Preliminary Plan No. 120130050 and Site Plan No. 820130060: Trotters Glen

Staff Report Date 07/11/13

***A. Preliminary Plan No. 120130050: Trotters Glen (with a Final Forest Conservation Plan)**

***B. Site Plan No. 820130060: Trotters Glen**

Image5

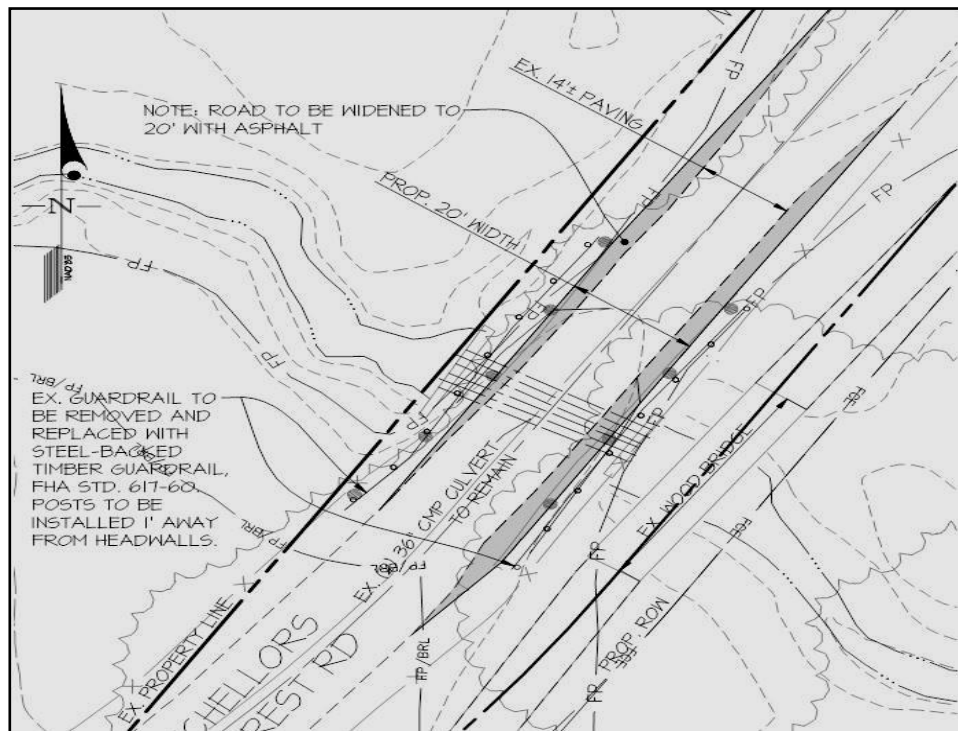
The original request from MCDPS was to remove the existing fence, and reconstruct it outside of the dedicated right-of-way; approximately 35 feet from road centerline. MCDPS later agreed to allow the fence to remain within the right-of-way but would not allow for future maintenance, which was considered by Staff and the Rustic Roads committee as demolition by neglect and did not find this

provided adequate protection of Batchellors Forest Road’s rustic character. Another option considered was dedicating only 50 feet of right-of-way and two ten foot wide easements for future dedication. This would have allowed the reconstruction of the four board fence out of the right-of-way at approximately 25 feet from roadway centerline. Because of concerns raised by MCDOT about receiving reduced right-of-way, the Applicant, MCDOT and MCDPS ultimately agreed to provide full dedication of 70 feet for Batchellors Forest Road, with a reconstructed and maintained fence located 25 feet from centerline of the pavement of Batchellors Forest Road.

Image10

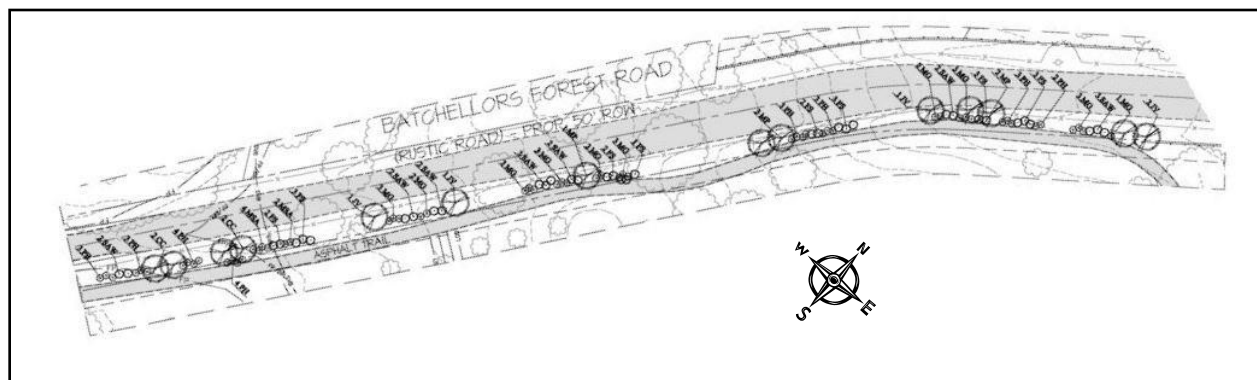
After discussion with Staff, the Applicant has agreed to provide additional plantings pending approval from MCDOT along the southeast side of Batchellors Forest Road, from the western Property boundary up until the four-board wooden fence begins (Image 10). Originally, Staff had asked that a wooden fence be rebuilt along the entire length of Batchellors Forest Road; however an existing cart path the Applicant wishes to keep for public use was in the way. To keep the feeling of Batchellors Forest Road narrow and rustic, and to provide some separation between the road and the path, the Applicant will provide plantings of various grasses and trees to recreate a hedge row along the road. As with the other landscaped areas, the idea was not to create a wall of vegetation but to create some visual and physical separation without completely blocking access or views.

Image 11

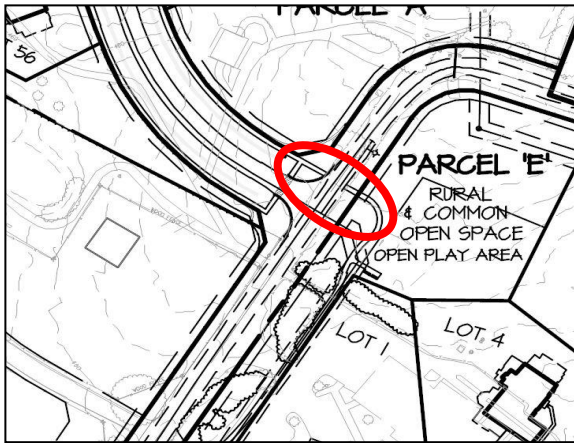
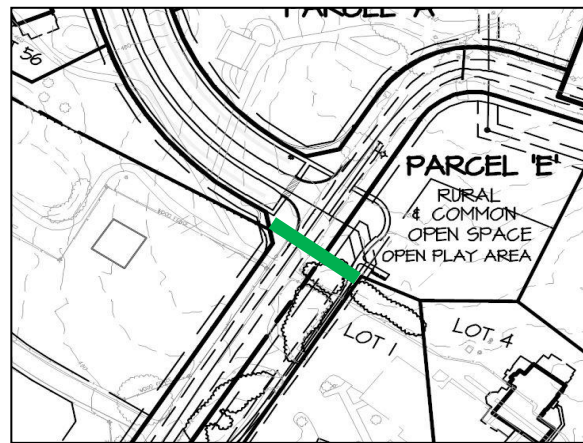
Staff and the community did identify one area of concern with regard to pedestrian safety; the location of pedestrian crossing on Batchellors Forest Road. There is one crossing identified on the Site Plan, located on the north side of the intersection of Public Road “B” and Batchellors Forest Road (red oval, Image 11). There is a concern that site distance may be limited by the presence of a 90 degree curve in the road, located 130 feet north of this location. Although Staff feel there is adequate site distance considering the presence of the 90 degree bend in the road, the Applicant is willing to move the crossing south by approximately 65 feet, to cross at the south side of the intersection of Public Road B and Batchellors Forest Road (green bar, Image 12). This additional 65 feet make for a total distance of 195 feet from the curve in the road and the crossing.
